## **ARCHITECTURAL REVIEW COMMITTEE MEMORANDUM**

DATE: JULY 18, 2022

SUBJECT: KAPPE ARCHITECTS, ON BEHALF OF MICHAEL SHAHBAZ AND BRIAN GLASER, FOR MAJOR ARCHITECTURAL AND ADMINISTRATIVE MINOR MODIFICATION APPLICATIONS TO CONSTRUCT A 6,180-SQUARE-FOOT SINGLE-FAMILY RESIDENCE ON A 19,602-SQUARE-FOOT HILLSIDE PARCEL LOCATED AT 850 SOUTH VIA LAS PALMAS (APN: 505-082-011), ZONE R-1-C, SECTION 10 (CASES 3.4329 MAJ & 7.1652 AMM). (NK)

Sheet Title:  
BUILDING ELEVATIONS

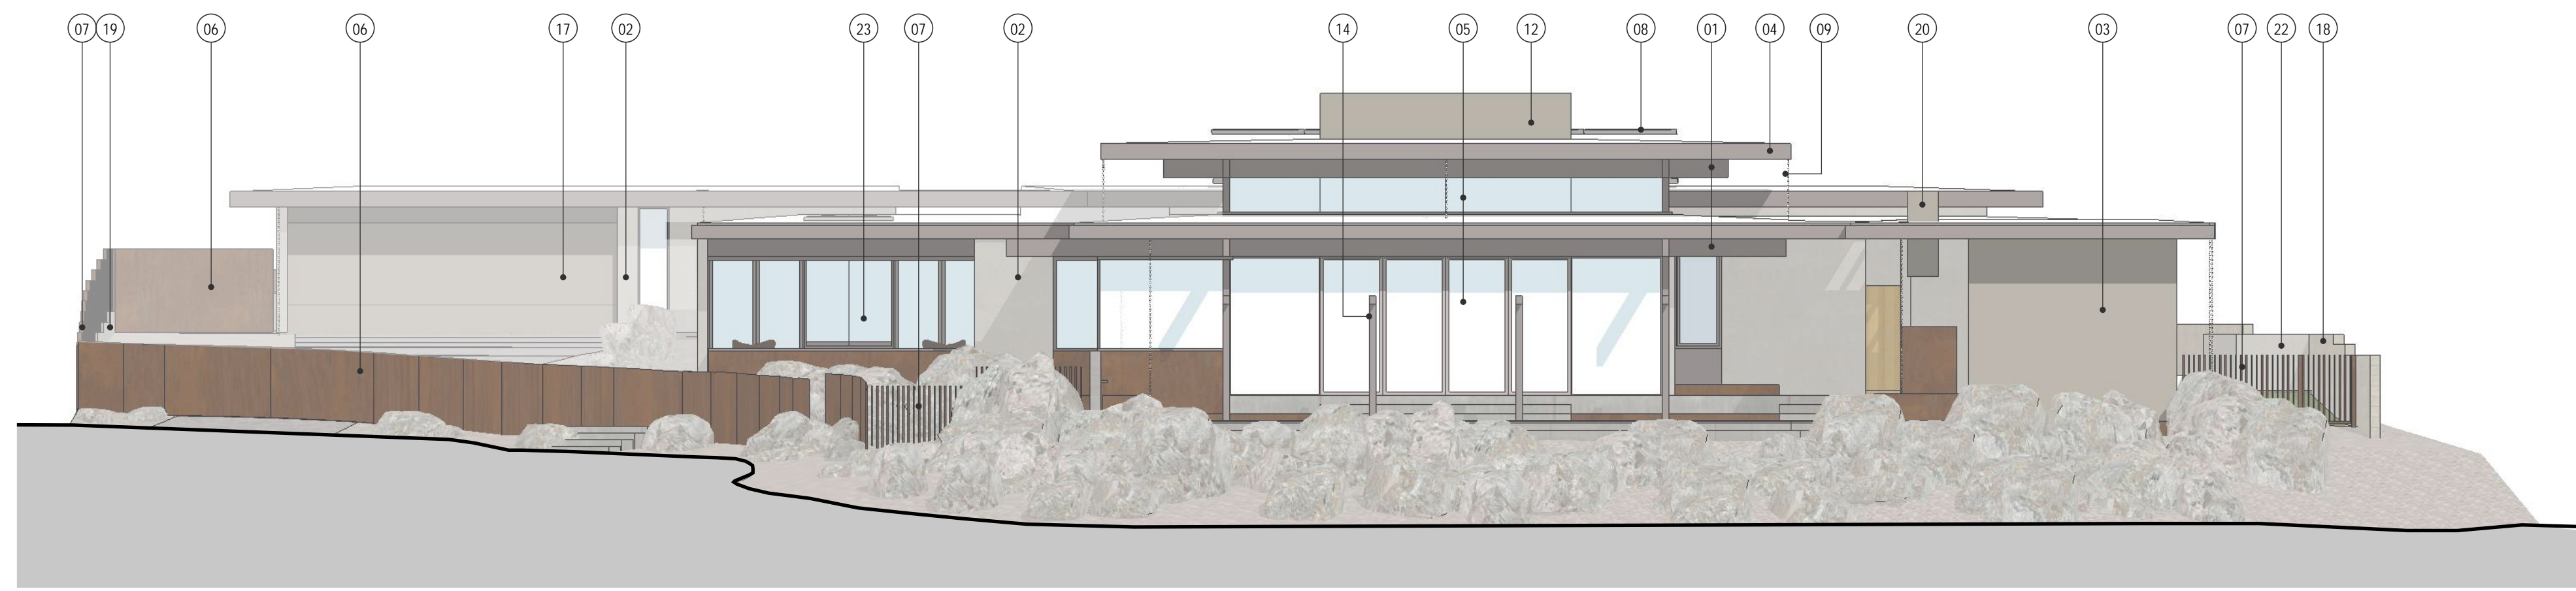
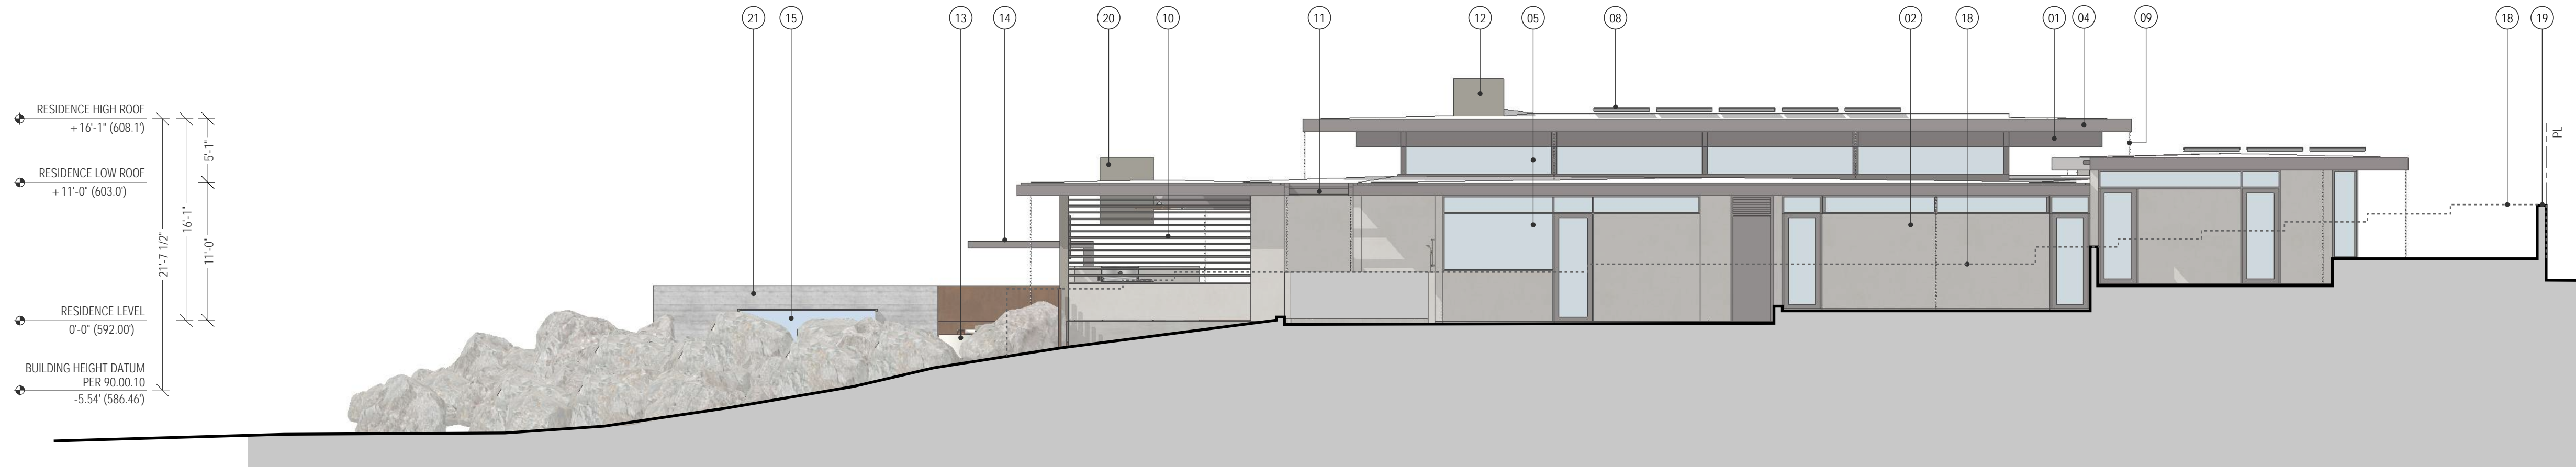
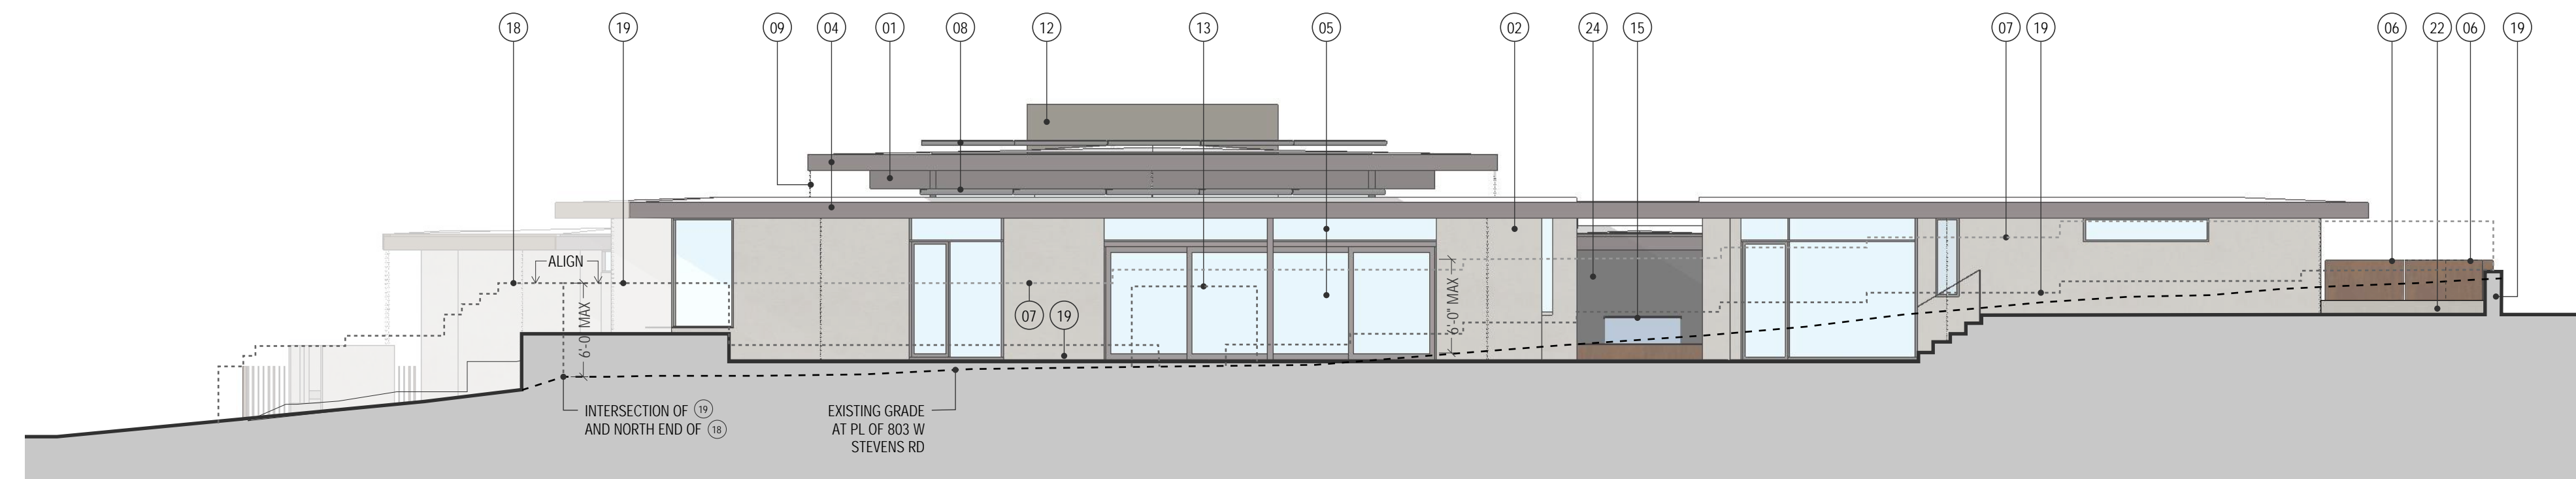
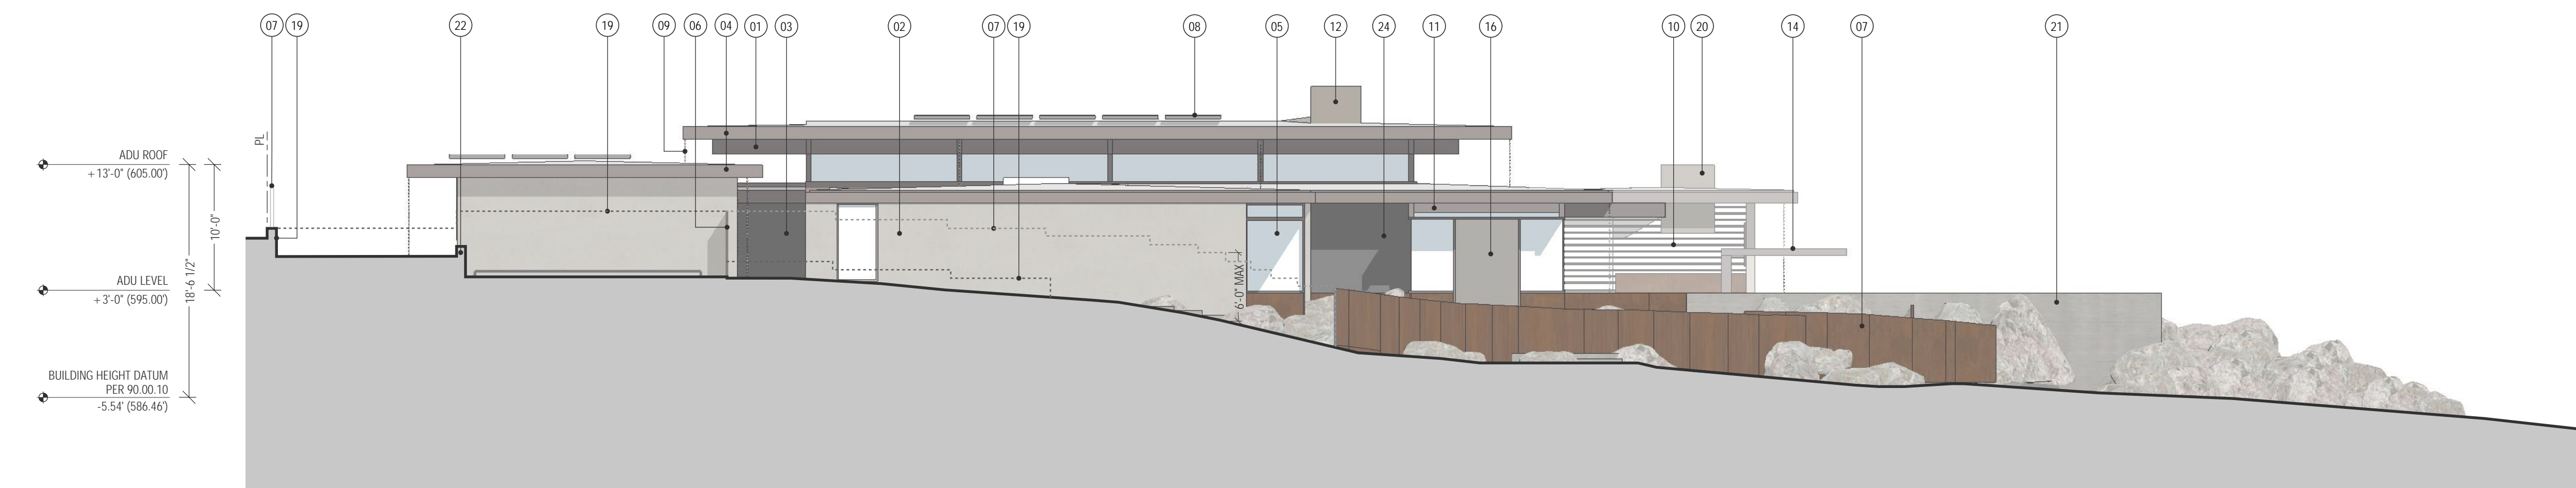
MODIFICATIONS TO BUILDING ELEVATIONS (A3.1) AND BUILDING SECTIONS (A4.1) AT THE REAR YARD:

SITE WALL AND FENCING AT NORTH PROPERTY LINE CLARIFIED ON NORTH ELEVATION, SHOWING EXISTING GRADE, OUTLINE OF SITE WALL, AND OUTLINE OF FENCING. FENCING ADDED TO BUILDING SECTIONS AT NORTH PROPERTY LINE.

2 | SECTION THROUGH GARAGE AND ADU

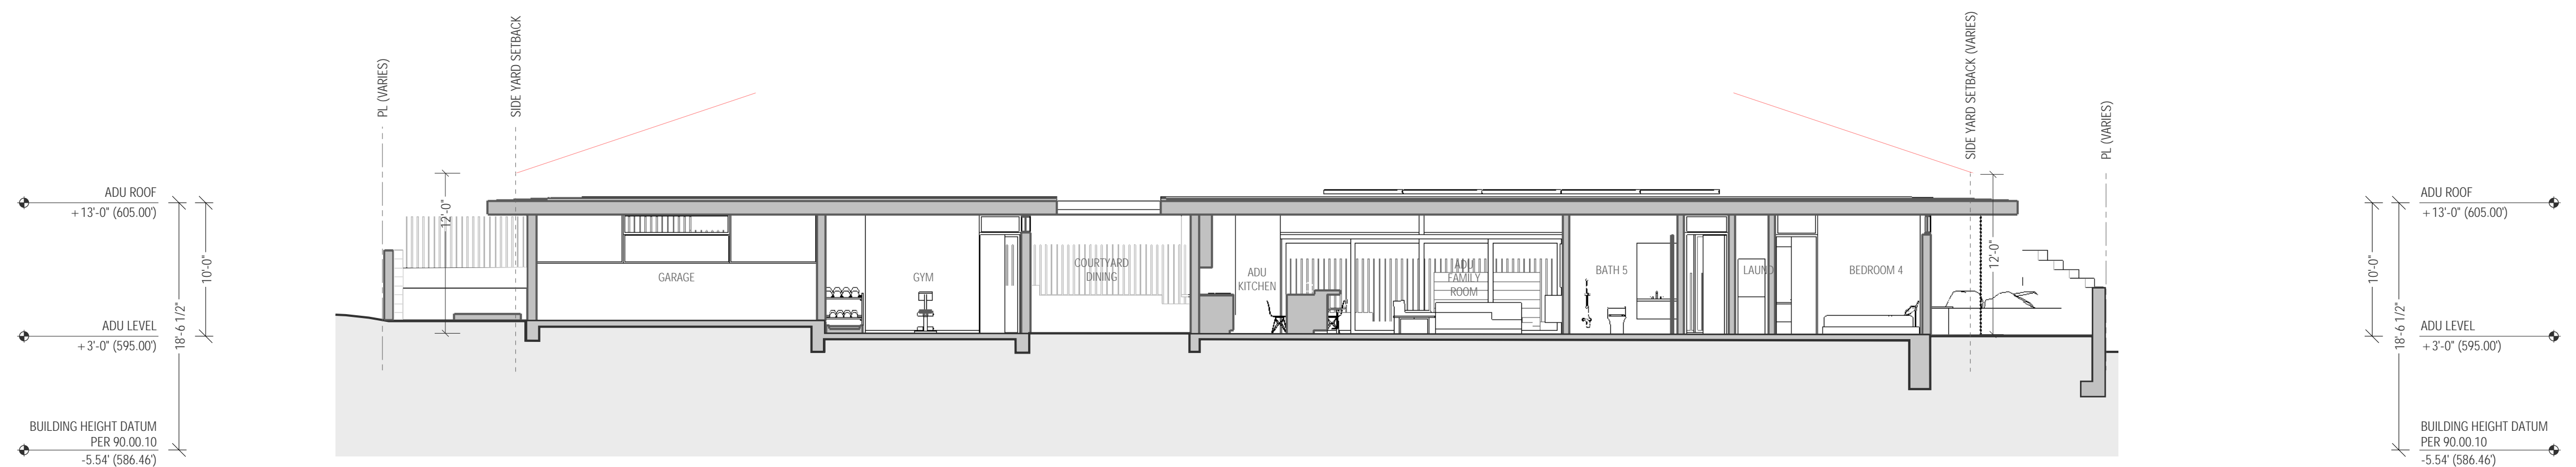
- PLN 1. Building Height. The building height of 13 feet measured at the rear portion of the residence (garage, office/gym, ADU) shall be subject to the approval of the Administrative Minor Modification (AMM) application, Case 7.1652 AMM.

1. **Requested Administrative Minor Modification to increase roof height to 19 feet ++. Is it necessary?** The architect said that the proposed roof height and overall density of the plan would not impact views from the east or the north of the property. We suggested that the architect (or contractor) conduct a story pole test and provide sight renderings from the properties to the north as was done for all impacted neighbors when we submitted the application for 803 Stevens Road. None of these renderings were included in the original packet. We would like to see this information and the story pole test before the review is completed.
